Subject: SLIC Case No. RO0002567, GeoTracker Global ID No. SL0600138148, Chung Property/Lane Metal Finishers, 2926-2942 San Pablo Ave, Oakland, CA 94608

Subject: SLIC Case RO0002567 and Geotracker Global ID SL0600138148, Chung Property,  
2942 San Pablo Avenue, Oakland, CA

Subject: SLIC Case RO0002567, Chung Property, 2942 San Pablo Avenue, Oakland, CA – Work Plan Approval

Requested Soil Vapor Sampling Locations

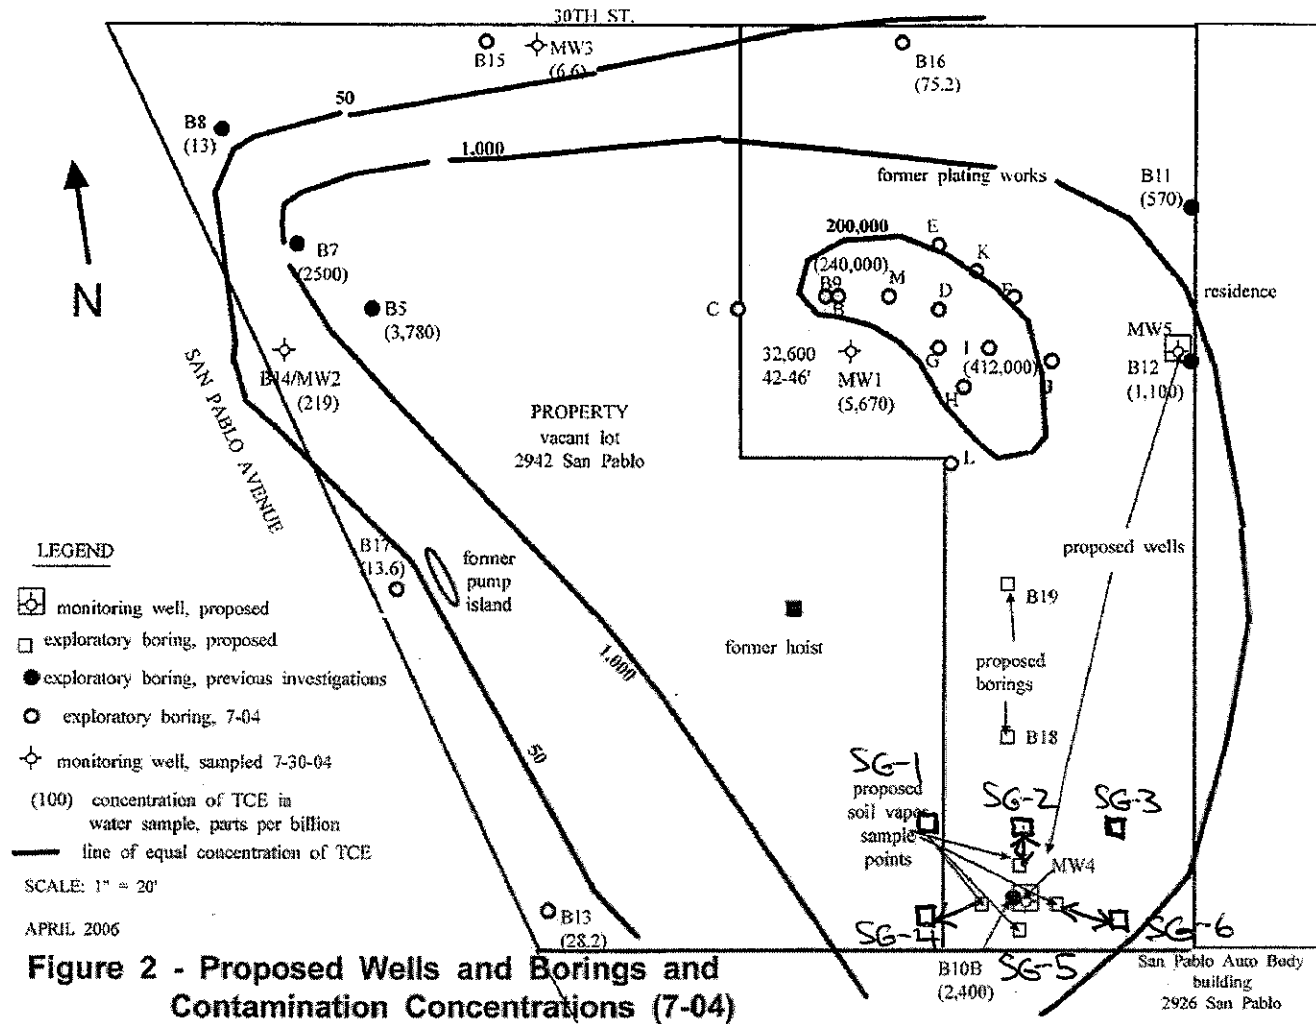
- 1. Soil Vapor Sampling near Boring B10B.** The Addendum proposes four soil vapor samples approximately 5 feet apart surrounding boring B10B. The purpose of the soil vapor sampling is to assess whether a source exists within the area of boring B10B. Therefore, we request that soil vapor samples be collected from six locations on a grid in the area around boring B10B as shown on the attached figure entitled, "Requested Soil Vapor Sampling Locations." We also request that soil vapor sampling be continued as necessary to define the extent of the source area if elevated concentrations of volatile organic compounds (VOCs) are detected in any of the soil vapor samples. The proposed methods for collecting the soil vapor samples are acceptable. Soil gas samples are to be analyzed for VOCs using EPA Method TO-15.

- 2. Soil Sampling for Metals and Cyanide.** In addition to the proposed twelve soil sampling locations, we request that four soil samples be collected from the hummocky area as shown on the attached figure, "Requested Surficial Soil Sampling Locations." When compositing soil samples in the laboratory, please assure that the four requested soil samples from the hummocky area are composited into one sample. If any analytes are detected at concentrations exceeding the Environmental Screening Levels, each of the discrete soil samples is to be analyzed.
